These amendments revise the Technical Specifications to allow operation of Oconee Unit 1 Cycle 4 at 100% full power with a flux tilt of 6.03% in an unrodded mode.

OCONEE NUCLEAR STATION, UNIT NO. 1

AMENDMENT TO FACILITY OPERATING LICENSE

ATTACHMENT TO LICENSE AMENDMENT NOS. 53, 53AND 50
FACILITY OPERATING LICENSE NOS. DPR-38, DPR-47 AND DPR-55
DOCKET NOS. 50-269, 50-270 AND 50-287

Figure 3.5.2-1A1

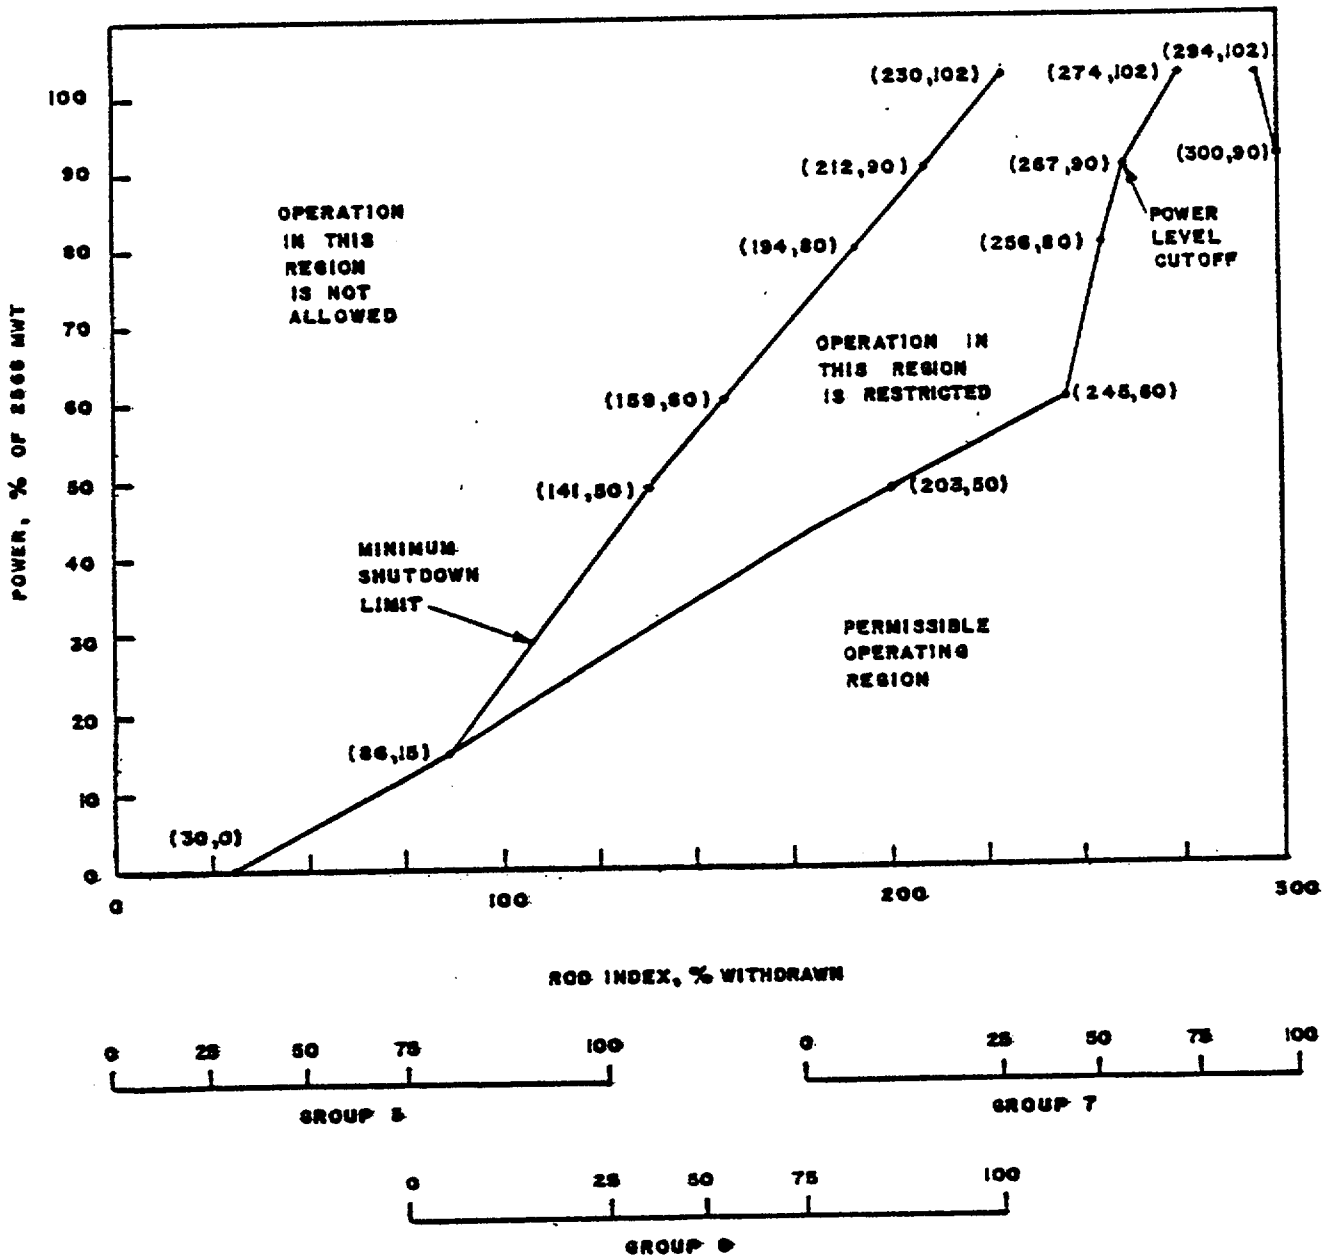
- c. Position limits are specified for regulating and axial power shaping control rods. Except for physics tests or exercising control rods, the regulating control rod insertion/withdrawal limits are specified on figures 3.5.2-1A1, (Unit 1); 3.5.2-1B1, 3.5.2-1B2 and 3.5.2-1B3 (Unit 2); 3.5.2-1C1, 3.5.2-1C2 and 3.5.2-1C3 (Unit 3) for four pump operation, and on figures 3.5.2-2A1, (Unit 1); 3.5.2-2B1, 3.5.2-2B2 and 3.5.2-2B3 (Unit 2); 3.5.2-2C1, 3.5.2-2C2 and 3.5.2-2C3 (Unit 3) for two or three

d. Except for physics tests, power shall not be increased above the power level cutoff as shown on Figures 3.5.2-1A1, (Unit 1), 3.5.2-1B1, 3.5.2-1B2, and 3.5.2-1B3 (Unit 2), and 3.5.2-1C1, 3.5.2-1C2, 3.5.2-1C3 (Unit 3), unless the following requirements are met.

OCONEE 1 CYCLE 4 ROD POSITION LIMITS FOR FOUR PUMP OPERATION FROM 0 TO 100 (+10) EFPD

Figure 3.5.2-2A1

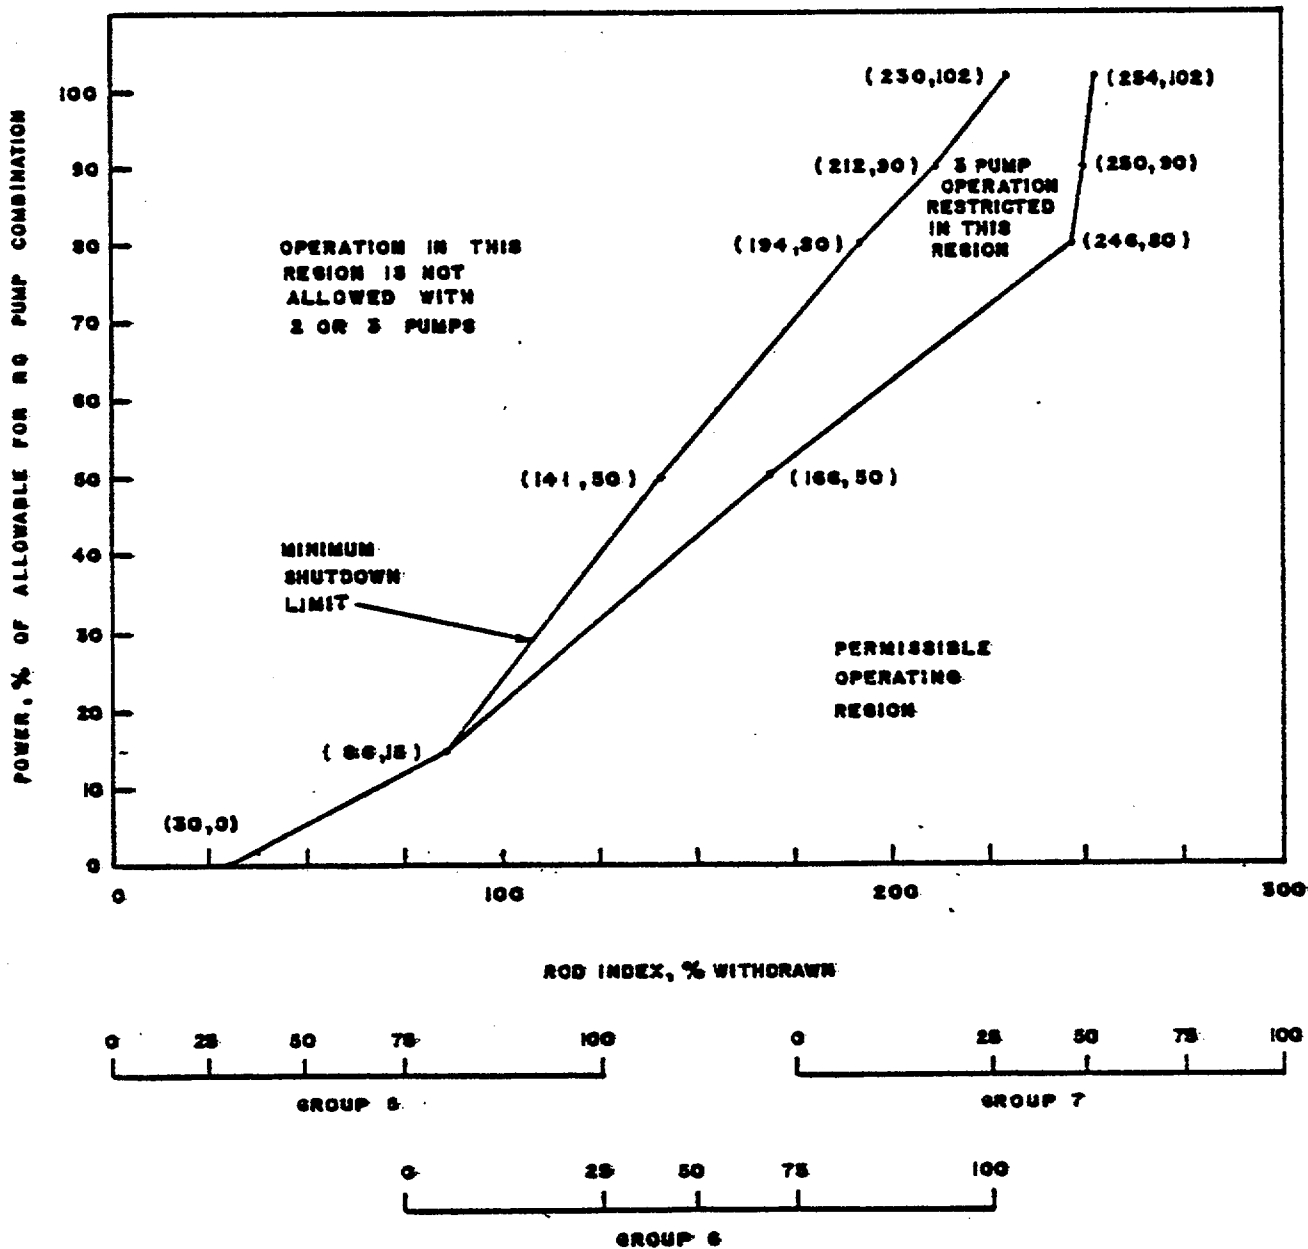
OCONEE 1 CYCLE 4 ROD POSITION LIMITS FOR TWO AND THREE PUMP OPERATION FROM 0 TO 100 (± 10) EFPD
 OCONEE NUCLEAR STATION
